Access Compliance Report Public Rights-of-Way (Pedestrian Signals)

Main Street: MOUNTAIN_VIEW_AVE Cross Street: KELLOGG_DR Location: N

ADA ID: SGAT210922123909 Signal Type: One Push Button-Non APS Overall Compliance: No Severity Scores: BTN 1: 35 BTN 2: N/A No BTN: N/A

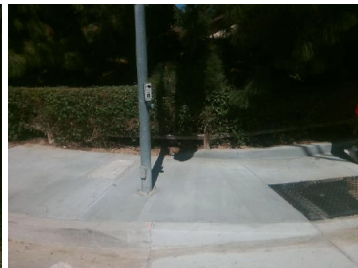
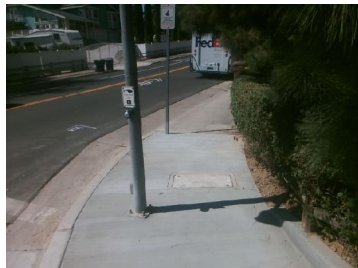
Codes/Mitigation Info/Possible Solution

OC Std/PROW: R404.2, MUTCD 4e.08

Possible Solutions: Replace Signal Push Button With APS Button. Remove and Replace Clear Space.
